STATE OF HAWAII
DEPARTMENT OF TRANSPORTATION HIGHWAYS DIVISION **GUARDRAIL DETAILS**

KULA HIGHWAY RESURFACING Kekaulike to Kula Sanatorium Kula Junction towards Lower Kula Road Fed. Aid Project No. STP-037-1(18)

**ADD. 19**

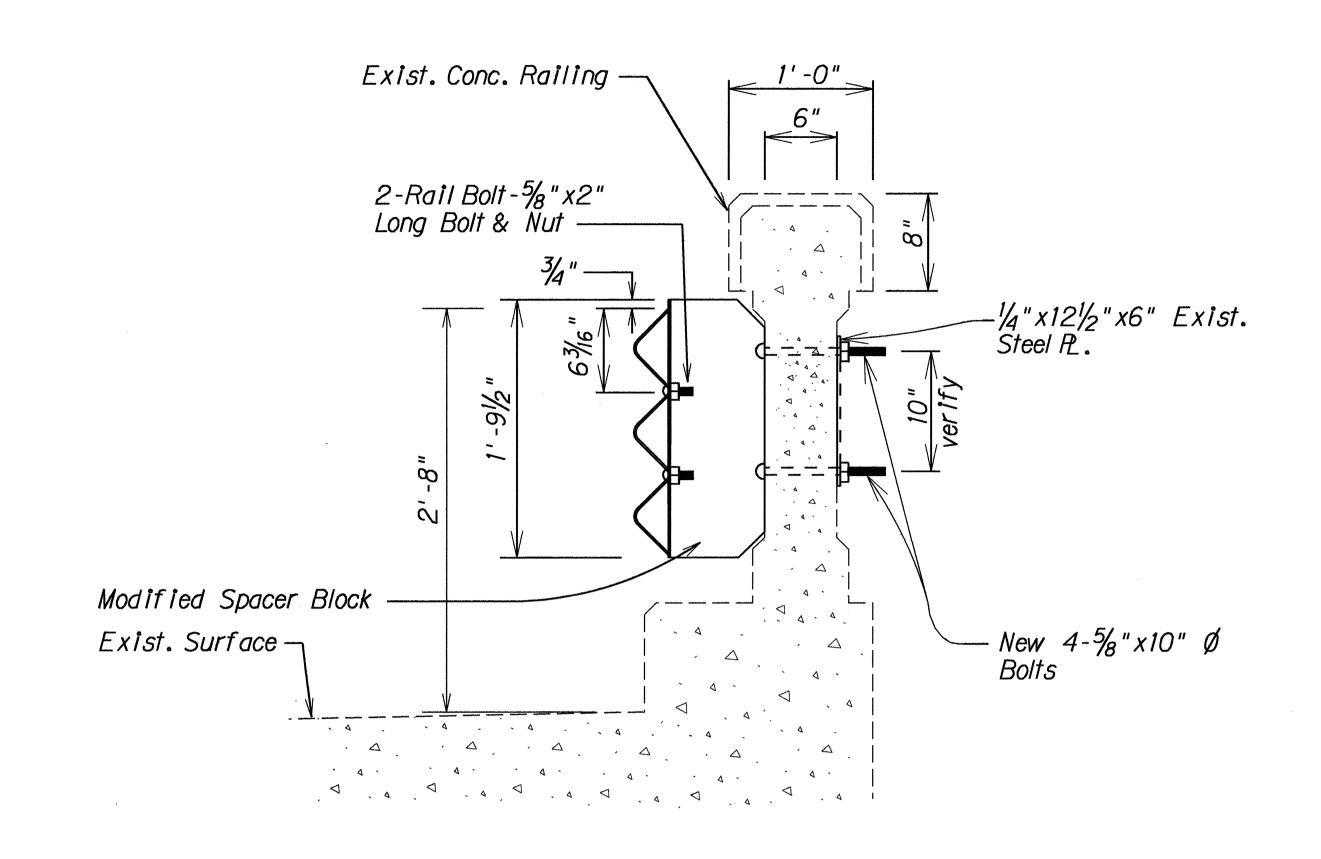
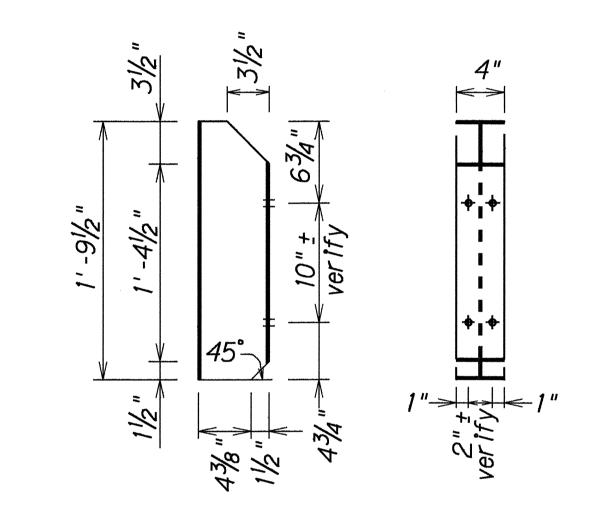
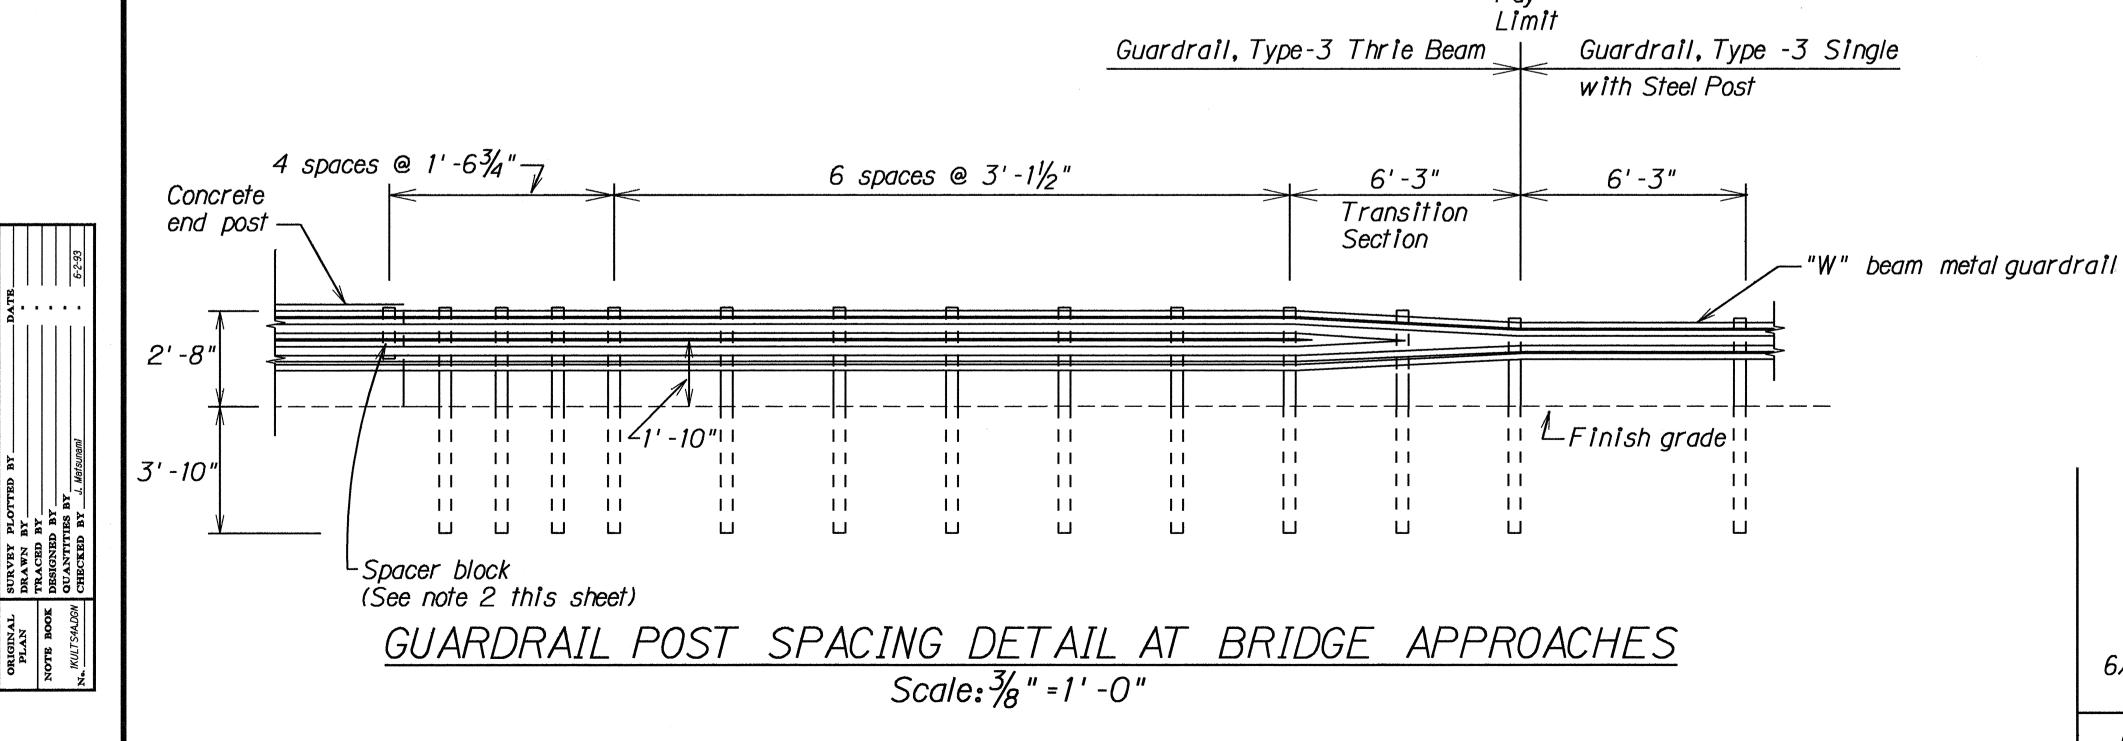
Added Post at Midpoint of Transition Beam 6/2/93 DATE REVISION
